**Critical Well Evaluation:**

WELL TEST ANALYSIS

Company: GMD 3  
 Project: 10335  
 Location: Morton County  
 Test Well: 10335

Data Set: C:\...\10335 Current.aqt  
 Date: 04/14/20

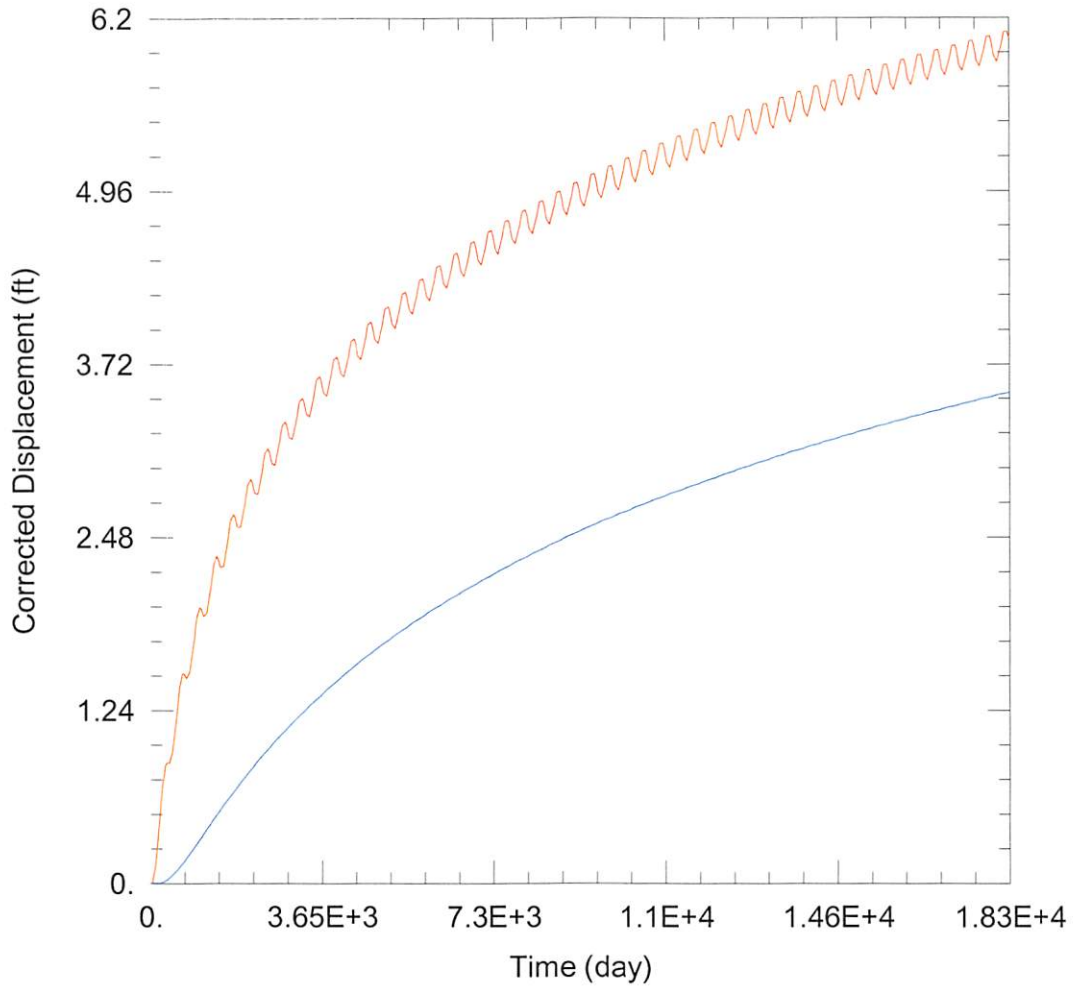
Based upon information from the GMD3 model, this proposal will cause effects on neighboring wells exceeding maximum allowable drawdown on critical wells. However, critical well evaluation found that neither of the two wells located within 1 mile of the proposed move are critical wells. Therefore, GMD3 staff recommends approval of the application.

Data Set: C:\...\10335 Proposed.aqt

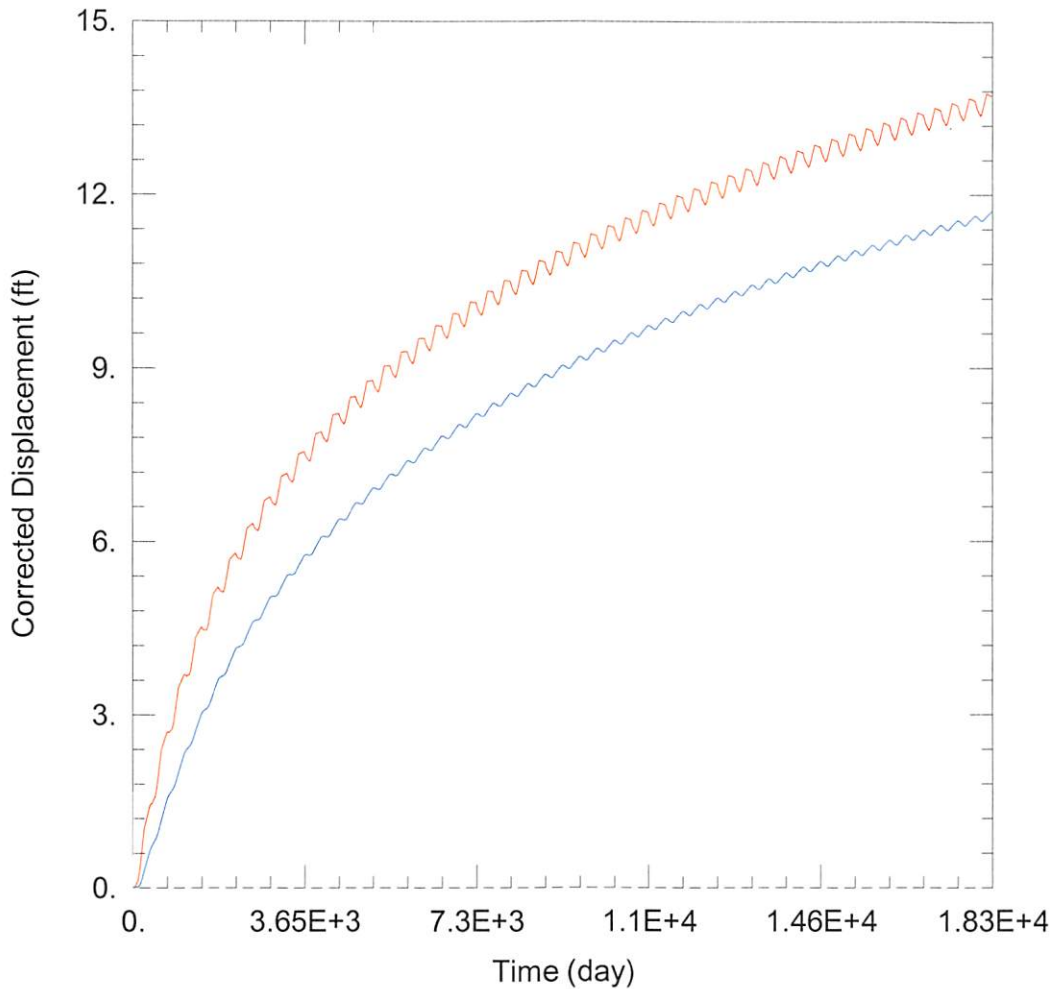
Net drawdown exceeds the drawdown allowance of 1.5 ft for both wells within 1 mile of the proposed location. Therefore, critical well analysis is necessary.
